From: Bard, Allison <Allison.Bard@croda.com>
Sent: Monday, November 20, 2023 1:38 PM
To: Rowland, Eric (DNREC)
Cc: Mann, Amy (DNREC); Okesola, Olayiwola (DNREC)
Subject: RE: Questions on Flare Permit Application
Attachments: Flare Site Plan.pdf

From: Rowland, Eric (DNREC) <Eric.Rowland@delaware.gov>
Sent: Tuesday, November 7, 2023 3:26 PM
To: Bard, Allison <Allison.Bard@croda.com>
Cc: Mann, Amy (DNREC) <Amy.Mann@delaware.gov>; Okesola, Olayiwola (DNREC) <Olayiwola.Okesola@delaware.gov>
Subject: Questions on Flare Permit Application

ECO FLARE SITE PLAN
PREPARED FOR
CRODA, INC.
NEW CASTLE HUNDRED
NEW CASTLE COUNTY - DELAWARE

TITLE		
ECO FLARE PROJECT		
SITE PLAN		
SITE PLAN		
SIZE	DRAWING NUMBER	REV.
D	684 21 214	4 of 4
		B 11.11.22

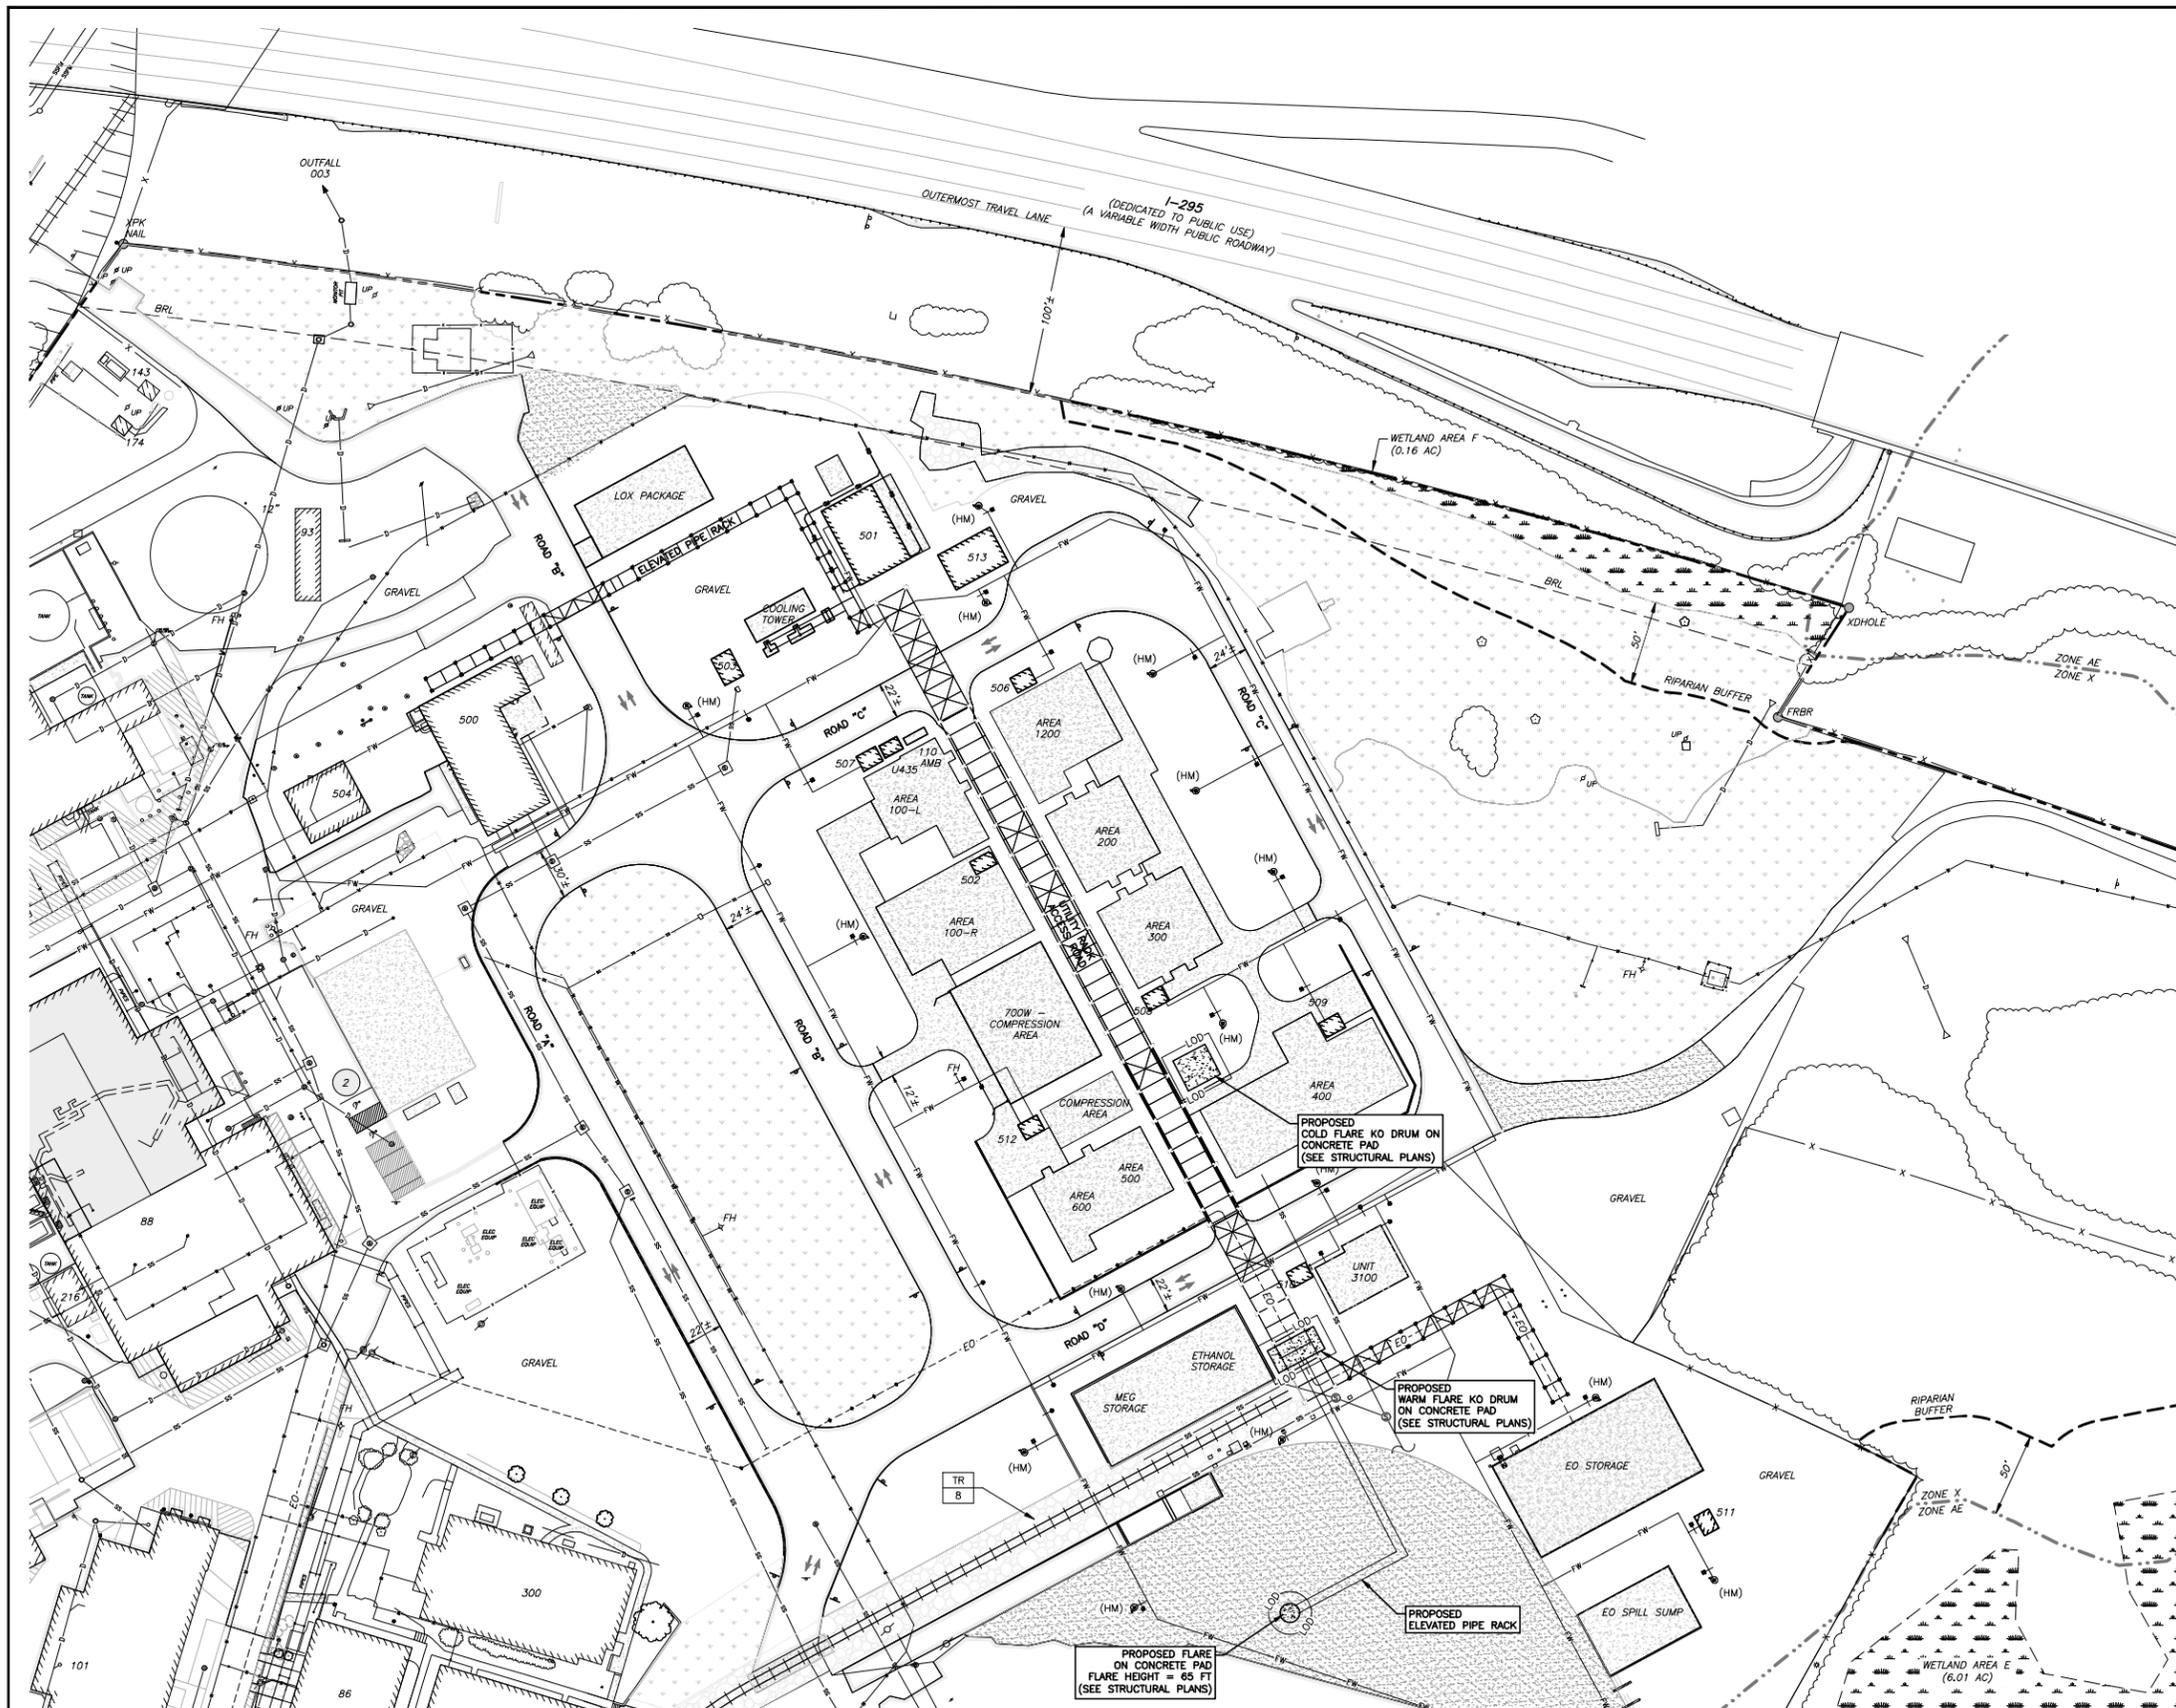
- Could you provide a site plan showing where this flare will be located? I seem to recall discussing this in the past, or having been shown a site plan with it labeled, but I do not see it included with the application. The latitude given on the application is also incorrect (typographical error), if you could provide the correct lat/long, that would be appreciated. **Site Plan Attached. Latitude: 39° 41' 36"**
